SR 3/US 41/Northside Parkway/ Cobb Parkway

**Project Number: BHFST-0001-05 (024), P.I. No.: 720125
and CSSTP-0009-00 (410), P.I. No.: 0009410
Fulton/Cobb Counties**

Value Engineering Study Report

August 2009

DESCRIPTION: **LEAVE THE RIGHT-OUT EXIT AT THE EXISTING IBM SOUTH ENTRANCE** SHEET NO. **1 of 2**

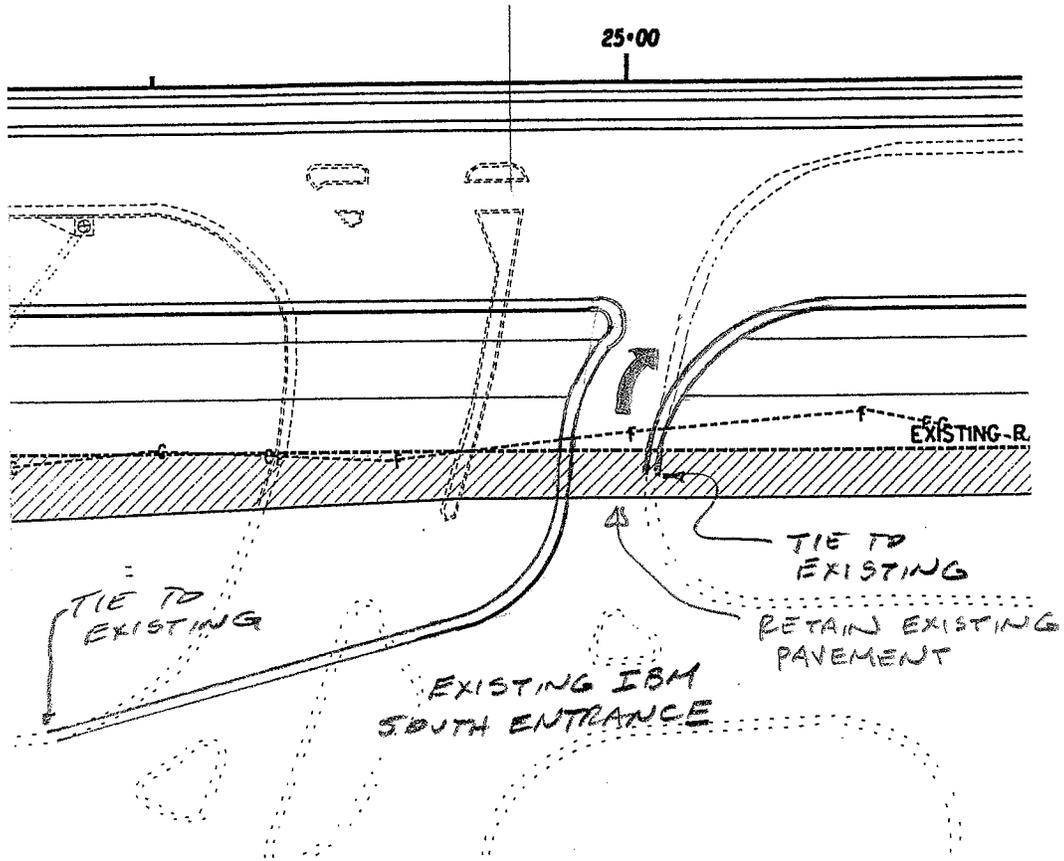
- Must provide a curb and gutter on the left side of the right-out driveway

SUBJECT: Sketch
Alt. R-4
Phase 1 & 2

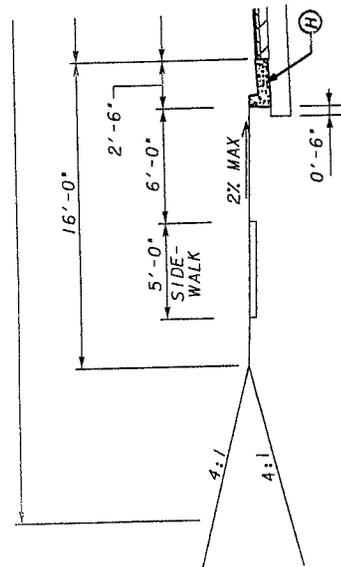
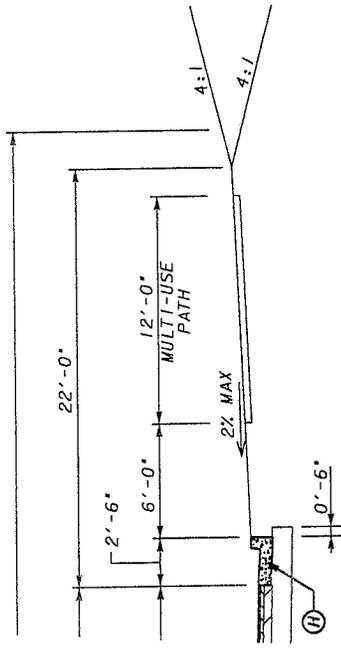
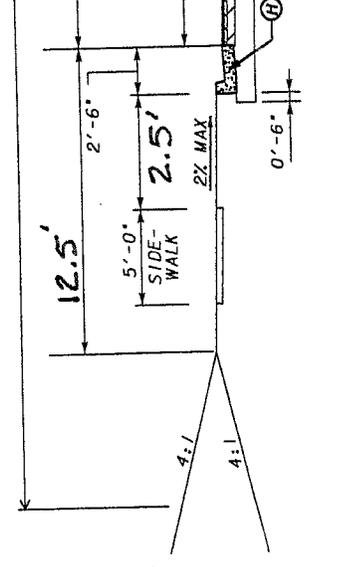
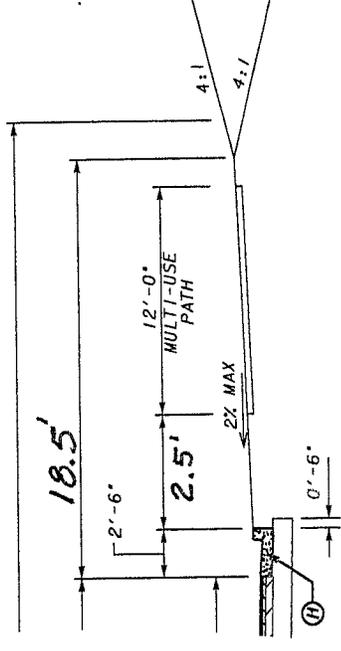
Narrow the grass strip to 2½-ft-wide to provide a 5 ft offset from the edge of travel lane to the (2½ ft curb and gutter and 2½ ft grass = 5 ft) sidewalk or multi-use trail. This would narrow the sidewalk shoulder to 12½ ft and the multi-use trail shoulder to 18½ ft.

The AASHTO bicycle/pedestrian manual, GDOT Design Manual and ADA require a 5 ft offset from the edge of the travel lane to the sidewalk or multi-use trail, which Alt. No. R-4 would provide. The current design provides an 8½ ft offset which could be narrowed by 3½ ft to still provide the required 5 ft offset. This alternative would save seven ft of right-of-way and excavation.
